RACE KIT

Cunningham Downhaul System / Boom Vang

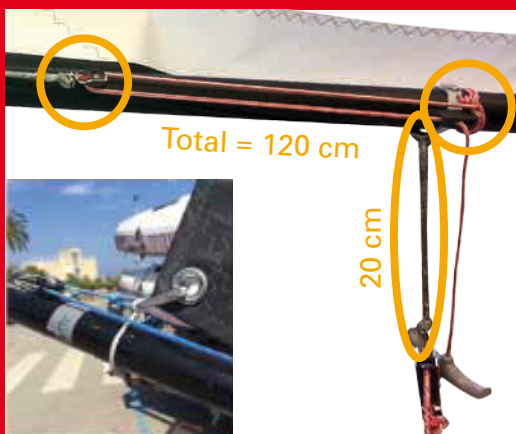
A) Add to the existing Cunningham Downhaul System: 2 x extra single pulley + extra rope 45 cm length. Cunningham downhaul rope lengthened to have a total length of 365 cm (320 cm original + 45 cm extra). Rig the system as shown in the photo to give an extra 2 pulleys leverage on the Cunningham System.

B) The extra length of the Cunningham Line may be secured to the Mainsheet Ratchet Block Attachment to facilitate use, particularly in strong winds.
